Access Compliance Report

Public Rights-of-Way

(Pedestrian Signals)

Intersection ID: N/A	Main Street:	Cross Street: N/A	Location: N/A
ADA ID: 8BCA1F15A302	Signal Type: One Push Button-APS	Overall Compliance: No	Severity Score: BTN 1: N/A BTN 2: N/A No BTN: N/A
Codes/Mitigation Info/Possible Solution		Field Measurements/Component Compliance

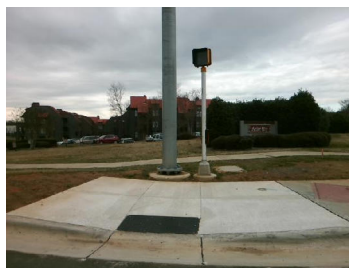
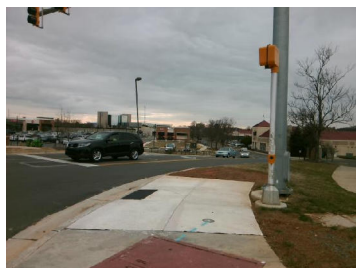
Surveyor Notes: NOT HOOKED UP, NOISES AND VERBAL COMMANDS UNKNOWN

PROW/ADA: TMUTCD 4e.08, R404.7.3, R404.7.2, MUTCD 4e.08, R104.2, R209.1,

Possible Solutions: Replace Signal Push Button With APS Button on New Post. Remove & Relocate Sign.
